<b>Committee Date</b>	05.08.2021	
<b>Address</b>	103 Foxgrove Road Beckenham BR3 5DA	
<b>Application Number</b>	21/01090/FULL6	<b>Officer</b> - Susanna Stevenson
<b>Ward</b>	Copers Cope	
<b>Proposal</b>	Demolition of existing side conservatory and erection of two storey side extension and single storey rear extension. New double height garage with office at first floor. REVISED DRAWINGS RECEIVED 09/06/21	
<b>Applicant</b>	<b>Agent</b>	
Bew	Tara de Linde	
103 Foxgrove Road Beckenham BR3 5DA	The Gardeners Cottage Knole Sevenoaks TN15 0RP	
<b>Reason for referral to committee</b>	<b>Councillor call in</b>	
	Call-In	Yes

<b>RECOMMENDATION</b>	PERMISSION
-----------------------	------------

PROPOSED SOUTH ELEVATION

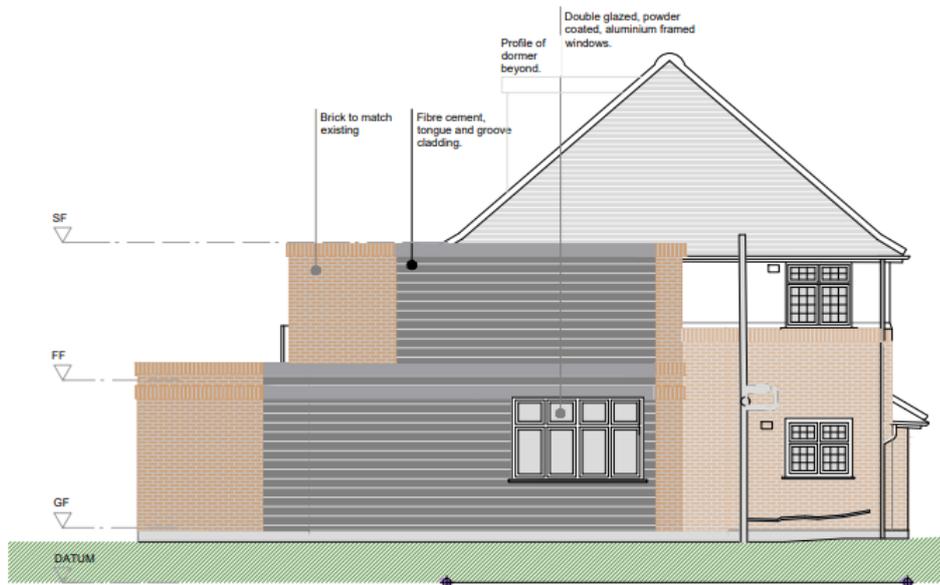
3.7 The first floor extension would have a flat roof and would be approx. 5.6m high. It would incorporate a Juliet balcony to the rear elevation (with no external projecting terrace or balcony as was originally proposed). Windows are proposed in the first floor rear elevation and within the eastern flank elevation. The eastern flank facing window would be positioned approx. 11m from the existing eastern flank elevation of the dwelling, with further separation to the eastern boundary of the site beyond.
